Subject: Inspection of the correct installation position of the fixing bolts of aileron- and air brake connector at the distributor.

Effectivity: s/n
TWIN ASTIR (incl. Trainer) 3000 - 3291
GROB G 103 "TWIN II" 3501 - 3729
(incl. ACRO)

Fig. 1 Aileron- and air brake connector at the distributor

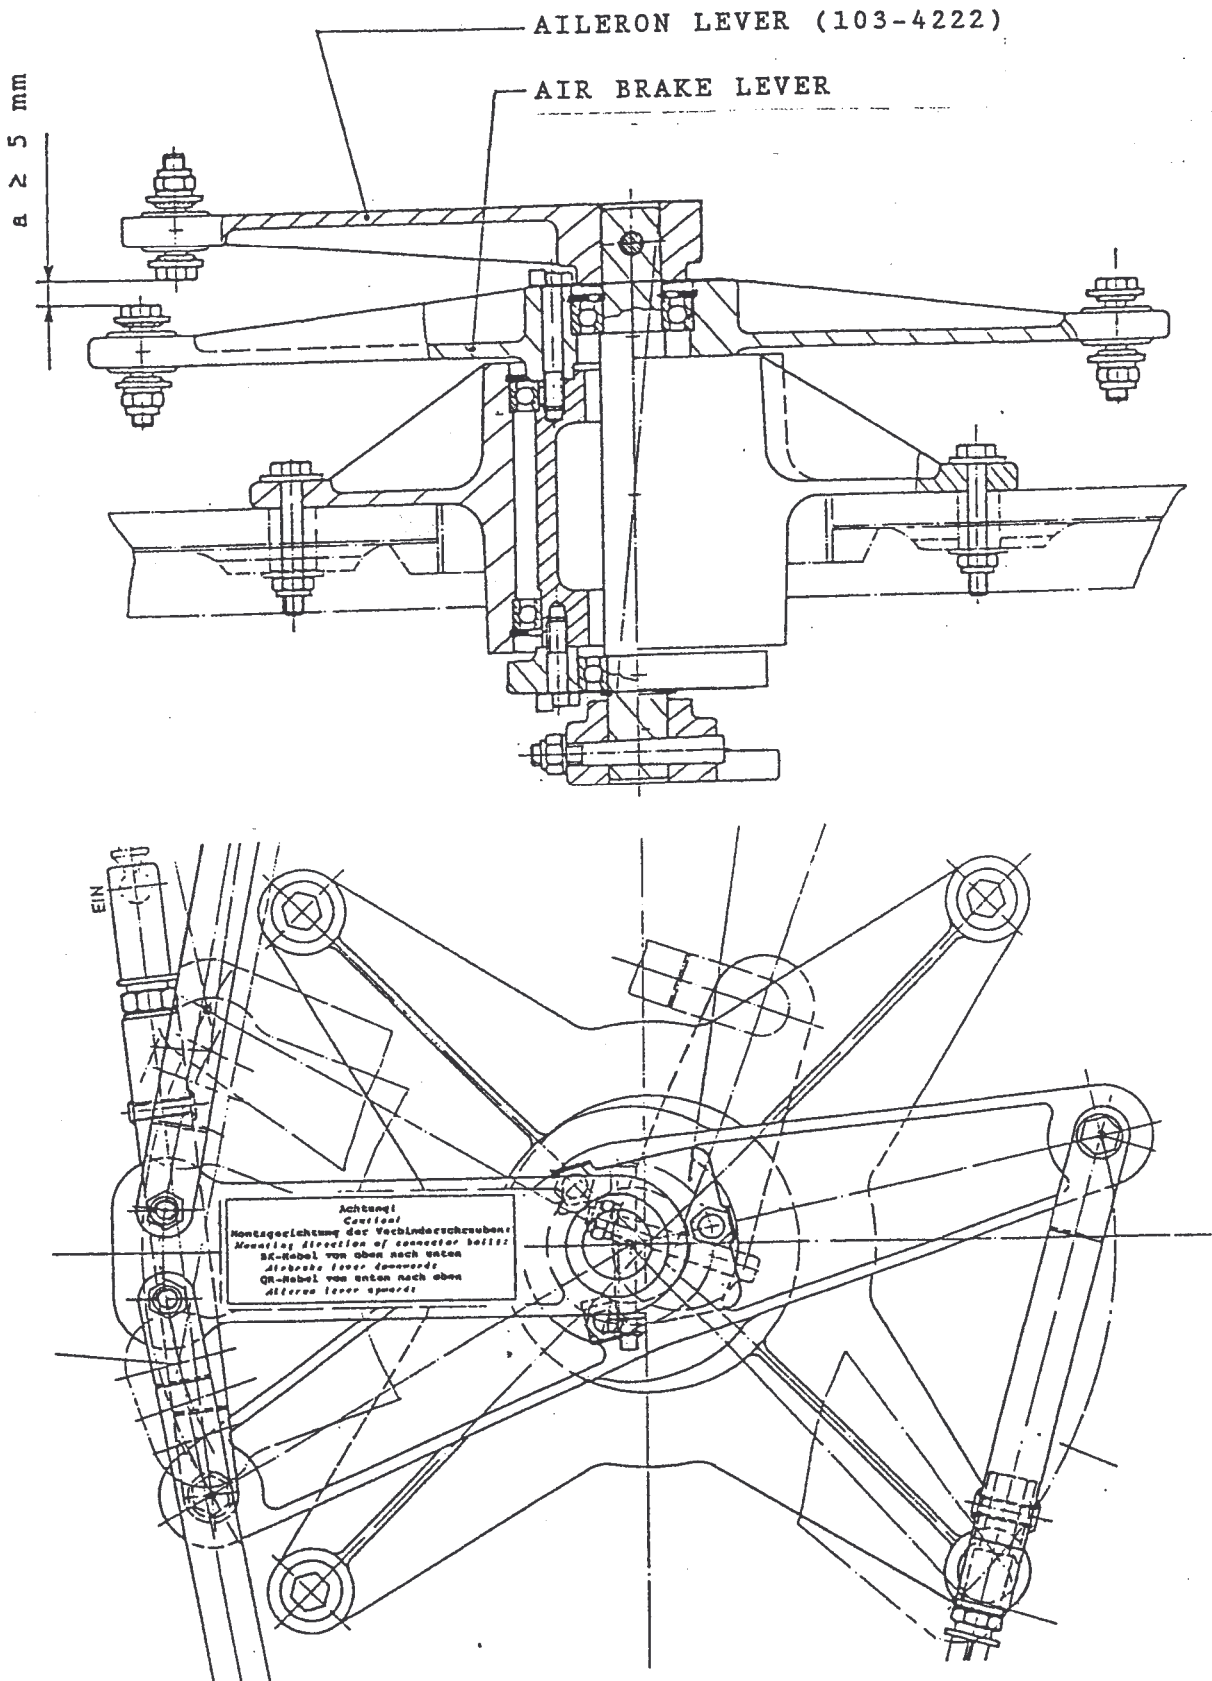
Reason: An accident investigation revealed that the owner of a TWIN ASTIR - probably when performing a service bulletin - mounted the fixing bolts on the aileron connector downwards. The manufacturer specifies installation upwards.

The wrong mounting of the bolts can lead to a reciprocal interference of aileron- and air brake control.

Instructions: Instruction 1
Checking of the correct mounting of the connector bolts (see fig. 1):

- 1.1 The following mounting direction of the bolts is mandatory:
- on the airbrake lever downwards
 - on the aileron lever upwards

The boltheads must have a minimum distance of $a = 5$ mm to each other.

3.2 Gluing of the placard (see fig. 1) with glue (e.g. PATTEX).

All bolts that have been incorrectly installed have to be removed and reinstalled observing the correct installation position according to fig. 1 and using new stop nuts.

2.2 Obtaining the minimum distance.
If the required minimum distance of $a = 5 \text{ mm}$ is not obtained, the manufacturer has to be contacted immediately.
